September 20, 2016

RE: Clarification to the specified vegetation in Table 4-1 of the Edwards Aquifer Habitat Conservation Plan (EAHCP) Biological Goals for fountain darter habitat in the Comal River for the Incidental Take Permit (#TE-63663A-1).

Edwards Aquifer Habitat Conservation Plan Nonroutine Adaptive Management Proposal

To: EAHCP Committees
From: Nathan Pence, Program Manager
Date: September 1, 2016
Re: Submerged Aquatic Vegetation Restoration Programs

Long-term Biological Goal reaches and proposed “restoration reaches” for the Comal system.

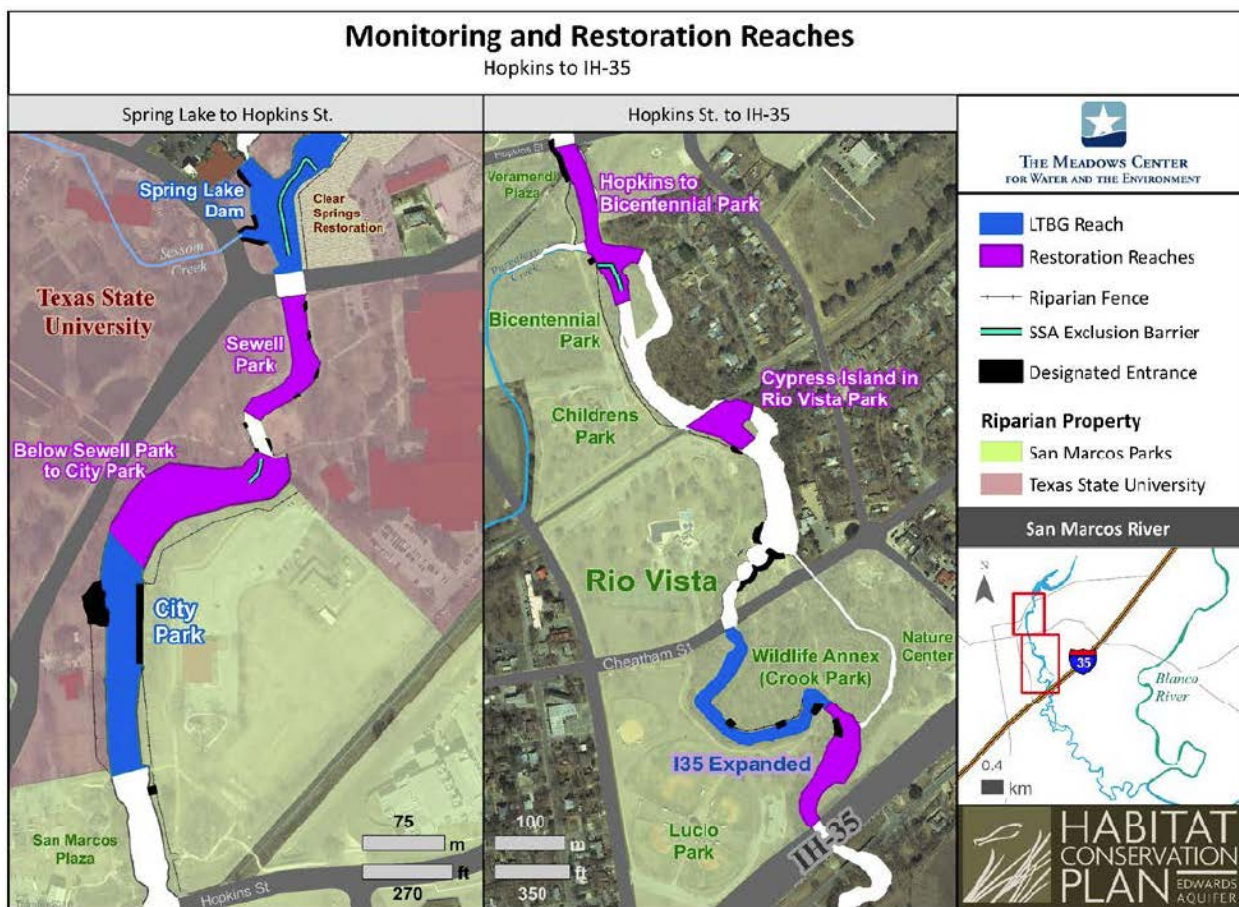
Carol Patterson (Edwards Aquifer Authority) added a comment concerning restoration reaches. Mrs. Patterson pointed out that the restoration reaches would add additional habitat for the fountain darter that should also be taken into account when considering the impact of the Nonroutine AMP proposal on the overall numbers of fountain darters. Mrs. Patterson also commended the proposal for achieving significant expansion of SAV restoration activities while keeping the budget within the limitations set by Table 7.1
